PRODUCT UPDATE

#196

Subject: 4B Series: M Type Collet Reduction Cone Shape Change

D and M type collets for B series

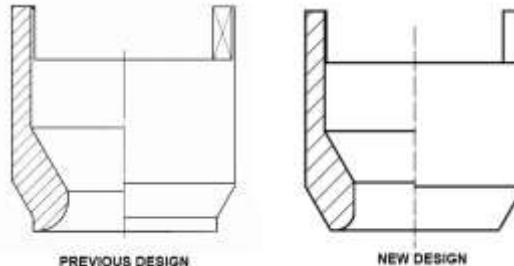
Details: The shape of the reduction cone used in the 4B undersize collets will change slightly. The inner diameter remains the same, but the rear exterior section now has a different profile.
